**CANTOR, FITZGERALD
SECURITIES CORP.**
105th FLOOR
ONE WORLD TRADECENTER, NEW YORK, N.Y.

**PROPOSED ALTERATION TO
G.S.B. TRADING ROOM
REFLECTED CEILING PLAN**

DRAWING NO. 105 R = 7

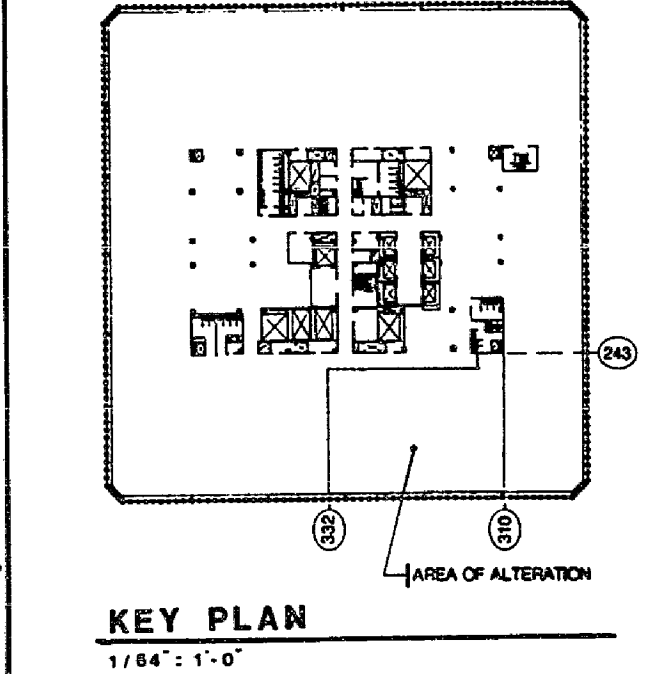
G-8-92	REVISED CEILING AREAS IN SPACE NO. 1, 3, & 412 PER PORT AUTHORITY COMMENTS, DATED 5-18-92, REVISED QUANTITY OF TYPE L-B FIXTURES	JEP
NO	DATE	REVISION	BY
